Access Compliance Report Public Rights-of-Way (Pedestrian Signals)

Main Street: **S_HEWES_ST** Cross Street: **CHAPMAN_AVE** Location: **SW**

ADA ID: **SGAT210929131814** Signal Type: **One Push Button-Non APS** Overall Compliance: **No** Severity Scores: **BTN 1: 10** **BTN 2: N/A** **No BTN: N/A**

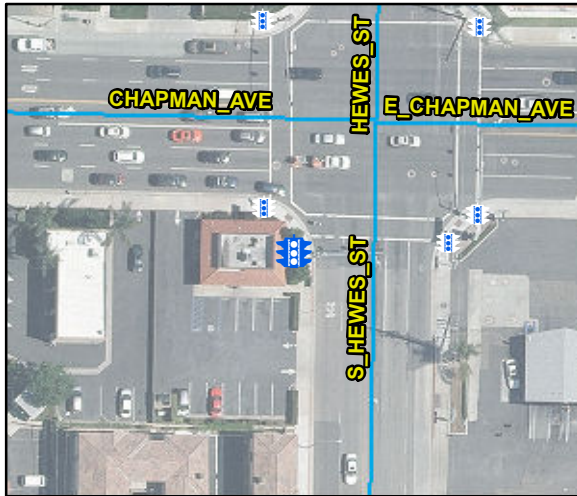
Possible Solutions: Replace Signal Push Button With APS Button. Remove & Relocate Sign.
